Access Compliance Report

Public Rights-of-Way

Intersection ID: 21120	Main Street: RUTHERFORD_DR	Cross Street: SULKIRK_RD	Location: NE
ADA ID: 050BF3BE5177	Ramp Type: PerpDiag	Initial Pass/Fail: Pass	Overall Compliance: No
Codes/Mitigation Info/Possible Solution		Field Measurements/Component Compliance	
Severity Score: 17.5

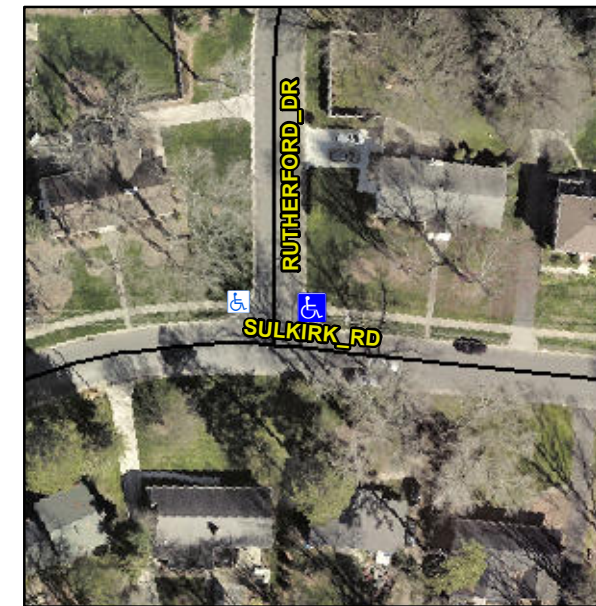
VERIFIED GUTTER SLOPES AS CORRECT, LIP HEIGHT 2.0

R304.2.1, R304.2.2-Perp, R304.3.2-Para, R305.1.4, R305.2, R302.7, R302.7.2

Remove & Replace Curb Ramp With Two New Directional Ramps or Equivalent. Grind Gutter Lip.
